Request for Additional Information No. 53 (1006), Revision 0

U. S. EPR Standard Design Certification

AREVA NP Inc.

Docket No. 52-020

Figure 19-209-1 – Illustration of Disabling Corresponding Trains for Specific Initiating Events

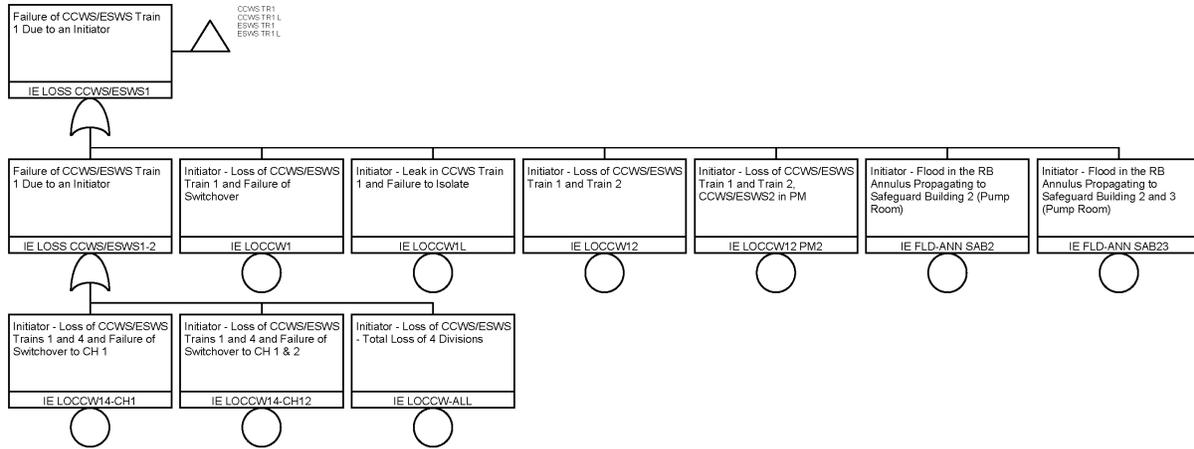
(Follow-up to Question 19-58) The response to Question 19-58 presents the differences between the various loss of component cooling water system (CCWS) and essential service water system (ESWS) initiating events. However, the success criteria and event tree provided in Appendix 19A of the FSAR treats loss of CCWS or ESWS as a single initiating event. So that the staff can clearly understand the impact of these initiators, amend Appendix 19A to specify the success criteria for each sub-initiator (e.g., in some cases, only two trains may be available; in others, the function may be guaranteed to fail). A single event tree is appropriate if the success criteria tables make clear which top events are applicable for each sub-initiator.

For each loss of component cooling water/essential service water (LOCCW/ESW) initiating event, the corresponding support system trains (CCW, ESW) are disabled directly in the fault trees. Since the support systems are not shown directly in the event trees, the same event tree (LOCCW) is used to propagate these events, even for the LOCCW-ALL initiator for which two of the functional events would be a direct failure (MHSI and MHSI 01). Disabling corresponding trains for specific initiating events (IE), as performed in the RiskSpectrum[®], is illustrated in Figure 19-209-1. Figure 19-209-1 illustrates that CCW Train 1 is disabled for IEs LOCCW1, LOCCW1L, LOCCW12, LOCCW12PM, LOCCW14-CH1, LOCCW14-CH12, LOCCW-ALL, and other initiators unrelated to CCS/ESW losses. ESW Train 1 is disabled for the same initiators. This feature of RiskSpectrum[®] allows for a straightforward modeling of the initiating event impact, and simplifies event tree modeling. It is not necessary to include the success criteria for the LOCCW initiating events to Appendix 19A, since the specific impacts of these initiators are defined in their description. These impacts are also defined in the response to RAI 7, Question 19-58 (a).
